**SDG&E 2/11/10 Response
A.09-08-003 East County Substation (ECO) PTC
Energy Division Data Request 1 Dated January 22, 2010
SDGE-ED-001: Q1-3**

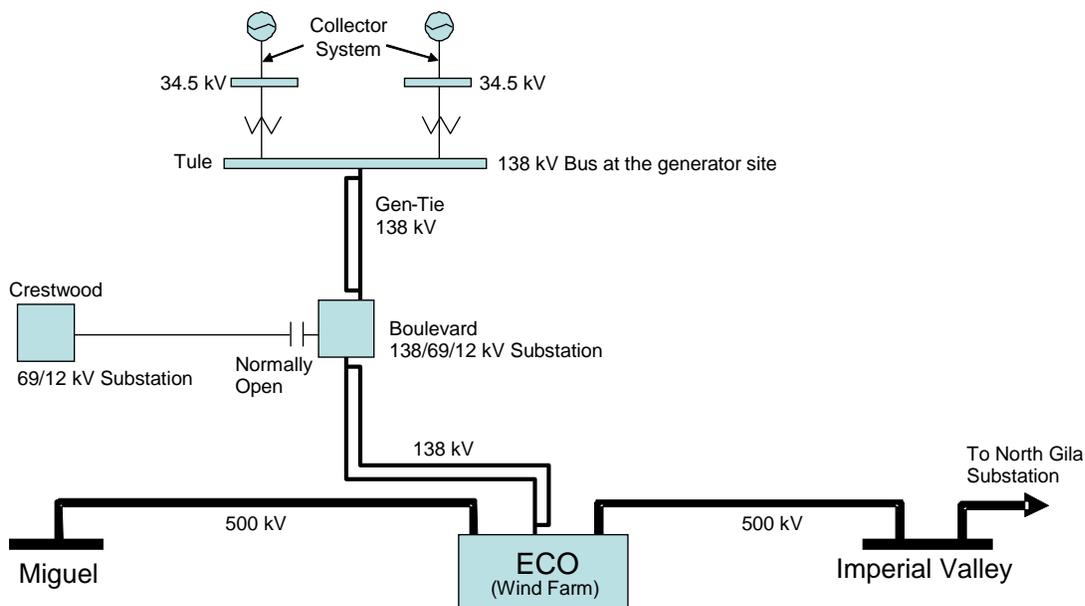
While the proposed upgrades to the Boulevard substation may make sense, the benefits from such upgrades could be short lived if the addition of the new wind generation results in the need for upgrades to the existing 69kV circuit back to Crestwood and Boulevard Tap. Please, provide studies (either internal or CAISO studies) that indicate the impact of the proposed ECO - Boulevard 138kV line and the new generation will have on the 69kV system in the area. If such studies are not available please provide a time frame in which they can be made available.

Additional studies are not needed to determine the impact of the proposed ECO - Boulevard 138kV line and the new generation will have on the 69kV system in the area.

Above is a one line diagram showing a wind generation plant connecting to the Boulevard Substation. Under normal operating conditions, the 69kV line from Boulevard to Crestwood would be normally open (Crestwood and Boulevard will not be electrically connected under normal operating conditions).

Under the rare circumstance that there is an outage (forced or planned) on the transmission line that connects Boulevard and ECO Substations, the generation will be tripped off and the connection between Crestwood and Boulevard will be closed to restore the power to the Boulevard area through Crestwood Substation. Considering this operating configuration there will be no impact on the existing 69kV system between Boulevard and Crestwood Substations, or to Crestwood Substation by the addition of generation to Boulevard Substation.
